UNITED STATES
NUCLEAR REGULATORY COMMISSION
WASHINGTON, D.C. 20555-0001

SUBJECT: NINE MILE POINT NUCLEAR STATION, UNIT NOS. 1 AND 2 - ISSUANCE OF AMENDMENTS RE: REVISIONS TO THE TECHNICAL SPECIFICATIONS DESIGN FEATURES SECTIONS TO REFLECT THE TRANSFER OF A PORTION OF THE NINE MILE POINT NUCLEAR STATION SITE REAL PROPERTY (TAC NO. ME6783 AND ME6784)

SAFETY EVALUATION BY THE OFFICE OF NUCLEAR REACTOR REGULATION
RELATED TO AMENDMENTS NOS. 212 AND 142 TO RENEWED FACILITY OPERATING
LICENSE NOS. DPR-63 AND NPF-69
NINE MILE POINT NUCLEAR STATION, LLC
NINE MILE POINT NUCLEAR STATION, UNIT NOS. 1 AND 2
DOCKET NOS. 50-220 AND 50-410

FIGURE 5.1-1
SITE BOUNDARIES
NINE MILE POINT - UNIT 1

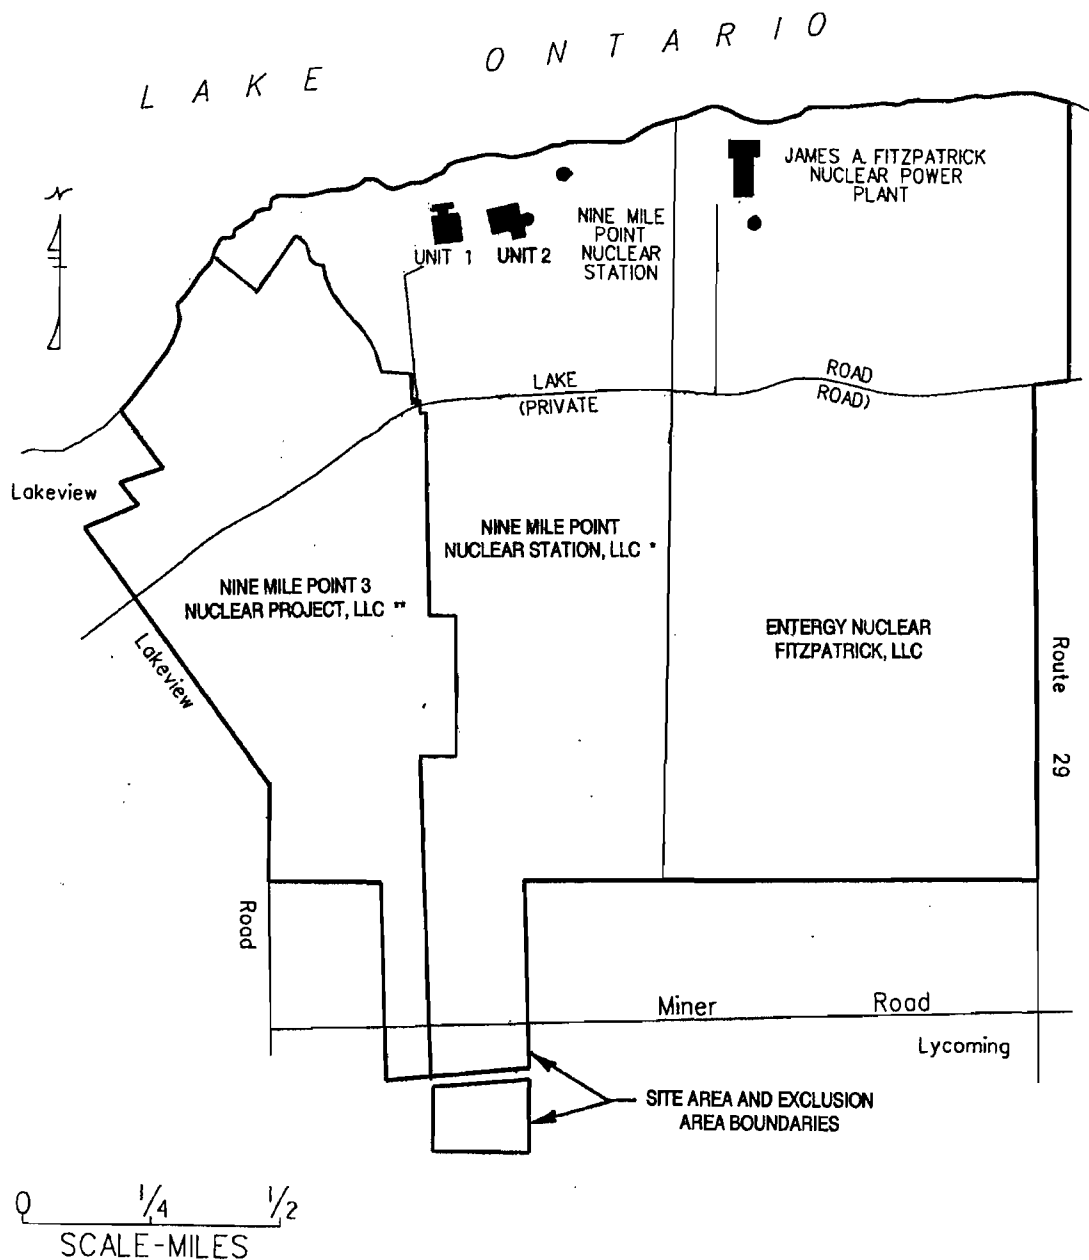
The amendments revised the NMP1 Technical Specification (TS) Section 5.1, "Site," and associated TS Figure 5.1-1, "Site Boundaries, Nine Mile Point - Unit 1," and the NMP2 TS Figure 4.1-1, "Site Area and Land Portion of Exclusion Area Boundaries," to reflect the transfer of a portion of the Nine Mile Point Nuclear Station, LLC (NMPNS) site real property located outside of the NMPNS Protected Area but within the current NMPNS Owner Controlled Area, as well as specified easements over the remainder of the NMPNS site, to Nine Mile Point 3 Nuclear Project, LLC (NMP3), a subsidiary of UniStar Nuclear Energy, LLC.

The primary change is to revise NMP1 TS Figure 5.1-1, "Site Boundaries, Nine Mile Point – Unit 1," and NMP2 TS Figure 4.1-1, "Site Area and Land Portion of Exclusion Area Boundaries," to reflect the transfer of a portion of the existing NMPNS site real property located outside of the NMPNS Protected Area but within the current NMPNS Owner Controlled Area to NMP3. On both of these figures, a new boundary line and associated label are applied to identify the portion of the NMPNS site that will be conveyed to NMP3, the COL applicant. In addition, the following footnote applicable to the property owned by NMP3 Nuclear Project, LLC is added to both figures:

Nine Mile Point Nuclear Station, LLC has easements to access and use the property owned by Nine Mile Point 3 Nuclear Project, LLC for security, emergency preparedness, and site monitoring purposes, by Agreement.

** Nine Mile Point Nuclear Station, LLC has easements to access and use the property owned by Nine Mile Point 3 Nuclear Project, LLC for security, emergency preparedness, and site monitoring purposes, by Agreement.
